Interactive comment on “31 years of hourly spatially distributed air temperature, humidity, and precipitation amount and phase from Reynolds Critical Zone Observatory” by Patrick R. Kormos et al.

Response to comments from Referee 1: 31 years of hourly spatially distributed air temperature, humidity, and precipitation amount and phase from Reynolds Critical Zone Observatory - ESSDD

Fig. 1. Figure 3 Revised

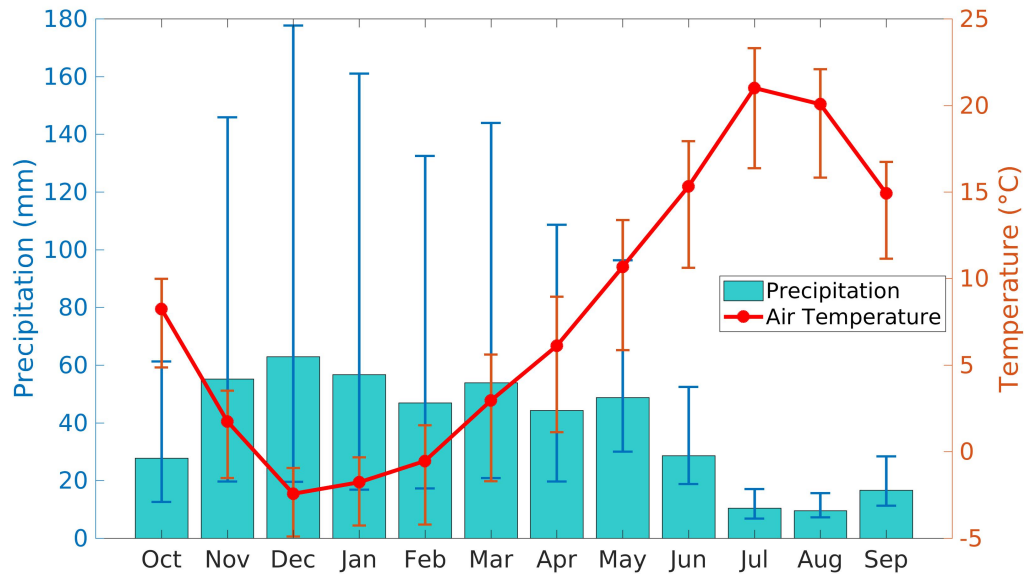
4. Pg. 4 Figure 3 I cannot discern the bottom uncertainty bound for precipitation in December and January, update figure as appropriate.

Thank you for your attention to detail. We have fixed this figure as suggested.
